Form 504	
U. S. COAST AND GEODETIC SURVEY	
DEPARTMENT OF COMMERCE	
DESCRIPTIVE REPORT	
Type of Survey	Hydrographic
Field No. SC21 & SC22	Office No. H-5474 H-5475
LOCALITY	
State	California
General locality	San Clemente Island
Locality	North Part Southern Part
<u>19<del>4</del> 33</u>	
CHIEF OF PARTY	
Robert W. Knox	
LIBRARY & ARCHIVES	
DATE	July 9, 1934

H-5475 H-5474  
TO ACCOMPANY HYDROGRAPHIC SHEETS NOS. SC 21 & SC 22

REVIEW OF HYDROGRAPHIC SURVEY NO. 5474 (1933).

REVIEW OF HYDROGRAPHIC SHEET NO. 5475 (1933).

Photostat of section of U. S. Coast and Geodetic Survey  
Topographic Sheet No. 4857, registered in Archives at  
Washington, D. C. Surveyed in 1933 on scale 1:10,000.  
Scale of photostat, 1:10,000. Date: Dec. 11, 1934

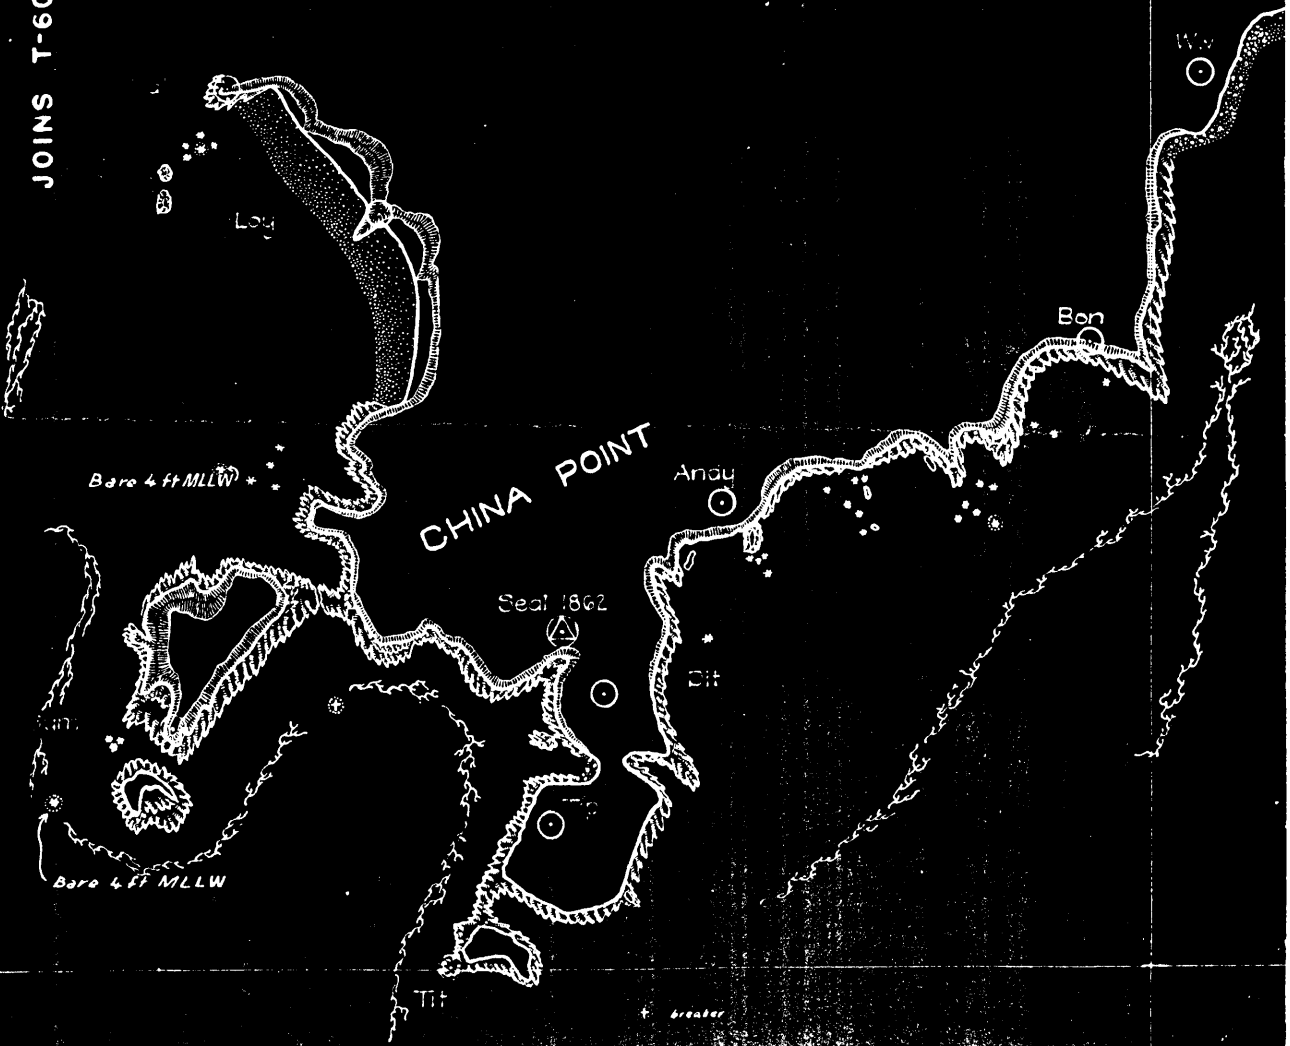
It is believed the discrepancy of rock symbols on the above sheet can be satisfactorily explained provided hydrographic sheet 5474 is the registered number of sheet SC22, and topographic sheet T-6089 is the registered number of sheet "M".

Topographic sheet 6089 (1:20,000) overlapped sheet 4857 (1:10,000) from signal Mal to the vicinity of the offlying island, and approximately the last mile of the former sheet was run in by E. M. Buckingham, Surveyor. Upon comparing the sheets in the office, it was decided to accept the detail on sheet 4857 because of the larger scale and the fact that the work was done by Lieut. Mathisson. In the meanwhile smooth sheet 5474 was constructed and plotted, in Long Beach, under the direction of the writer, while the topographic sheets were inked in San Diego under the supervision of Lieut. Mathisson. The sheets were submitted from the two places and no final check of breakers, etc., between the topographic and smooth sheets was made, as is the usual procedure.

The rock awash symbols, shown in red on the enclosed photostat, were originally shown on your topographic sheet 6089 and also hydrographic sheet 5474. These rocks were deleted from topographic sheet 6089 by the field party but were retained on the hydrographic sheet.

You will please advise the Office whether these rock symbols should be retained or deleted.

\* Delineation as shown on T. 4857 correct. all other rocks deleted from smooth sheet. See letter of, Feb. 18, 1936 (R.W. Knox) Filed in this P.R. 264.

\* It is respectfully recommended the rock symbols shown in red on the enclosed photostat be deleted.

\* See Review of H-5474, par. 9.  
Rocks as recommended have  
been deleted from smooth sheet, 5474.
